GUAM WATERWORKS AUTHORITY
Gloria B. Nelson Public Service Building | 688 Route 15, Mangilao, Guam 96913
P.O. Box 3010, Hagåtña, Guam 96932 Tel. No. (671) 300-6846/48 Fax No. (671) 648-3290

## IFB No. 2025-19 **Facility Damage Repairs Caused by Mawar** Response for Inquiries No. 3

This document addresses inquiries regarding IFB 2025-19. It provides clarifications and additional information for informational purposes. In the event that any responses result in modifications to the bid documents, they should be considered as amendments to the original IFB 2025-19.

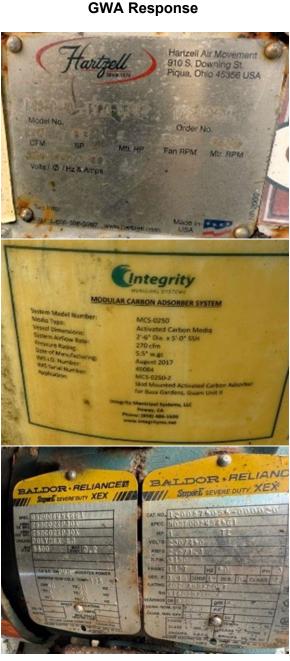
QUESTION/INQUIRY AS SUBMITTED:	GWA RESPONSE:			
Que	Questions from July 3, 2025				
1.	Kindly provide the specification of this items listed below:	Refer to page 2 for the response.

1.A42-0-10-F100FGFCH2 Odor control exhaust	Attached for your use is the revised Bid Cost Form as of July 17, 2025.			
	(Windward Hills Wastewater)	Additionally, GWA will be amending the following deadlines to provide all prospective			
	Penn Ventilator xr 60 exhaust fan     (Asan Wastewater)	bidders with sufficient time to update their bidding information and bid bonds as necessary.			
	SQUARE D Model 6 Control     (Yigo Wastewater)	New Deadlines as Follows: Deadline for Submission: 7/29/25 at 10 am

Q# Item Location GWA

A42-0-10F100FGFCH2 Windward Hills
Odor Control Wastewater
Exhaust Fan

Penn
Ventilator XR
1.2 60 Exhaust
Fan

Asan Wastewater

Alternate spec in use: Model: 5DDU16DB

Type: 16.5" Direct Drive Centrifugal Roof

Ventilator Style: Modern
